DESIGN <i>[Signature]</i>	DRAWN BY <i>[Signature]</i>	DART AEROSPACE LTD HAWKESBURY, ONTARIO, CANADA	
CHECKED <i>[Signature]</i>	APPROVED <i>[Signature]</i>	DRAWING NO. DSI 9149	REV. A SHEET 1 OF 1
DATE 99.04.01	TITLE ADD 205 SADDLE SPACERS		SCALE NTS
A	99.04.01	NEW ISSUE

DART SERVICE INSTRUCTION

AMEND INSTALLATION INSTRUCTIONS: D205-634 REV. B
D204-635 REV. B

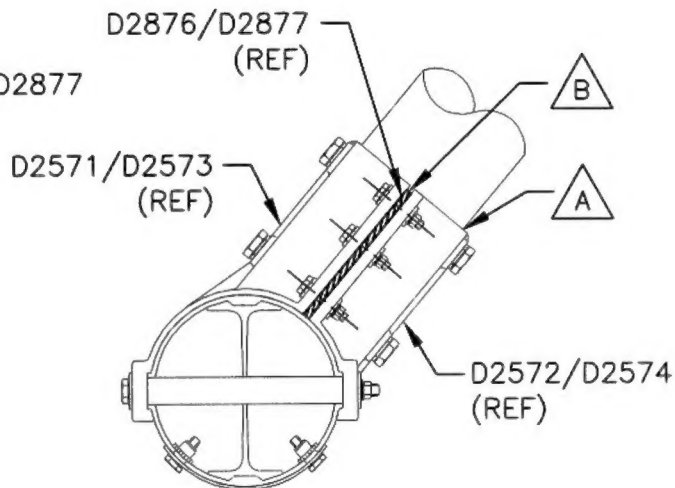
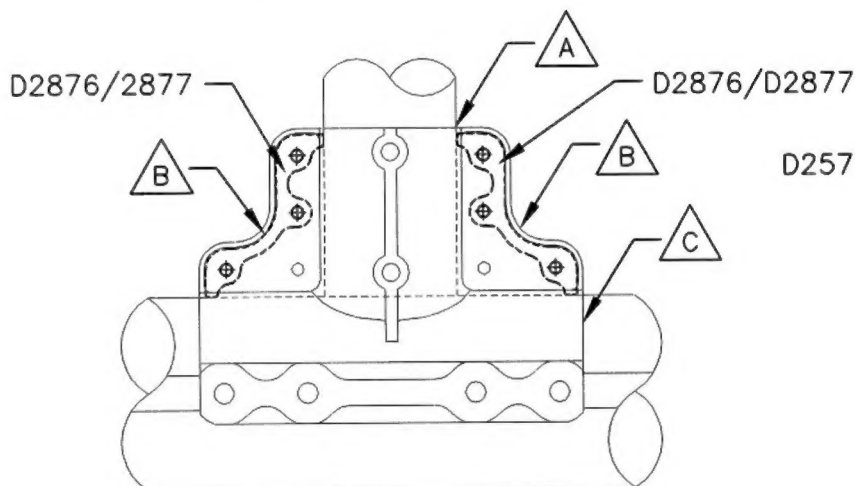
- 1) INSTALL (2) D2876 SADDLE SPACERS (1 ON EACH SIDE OF CROSSTUBE AS SHOWN BELOW) BETWEEN D2571/D2572 FWD SADDLE PARTS.
INSTALL (2) D2877 SADDLE SPACERS (1 ON EACH SIDE OF CROSSTUBE AS SHOWN BELOW) BETWEEN D2573/D2574 AFT SADDLE PARTS

- 2) TORQUE SADDLE FASTENERS PER DART INSTALLATION INSTRUCTIONS.
IT IS ACCEPTABLE FOR THE FLANGES TO BOTTOM OUT ON THE SPACERS.
- 3) APPLY A CONTINUOUS BEAD OF SEALANT IN ACCORDANCE WITH THE AIRCRAFT MAINTENANCE MANUAL IN THE FOLLOWING LOCATIONS:

-  ALONG SADDLE/CROSSTUBE INTERFACE
-  BETWEEN THE SADDLE FLANGES
-  ALONG SADDLE/SKIDTUBE INTERFACE
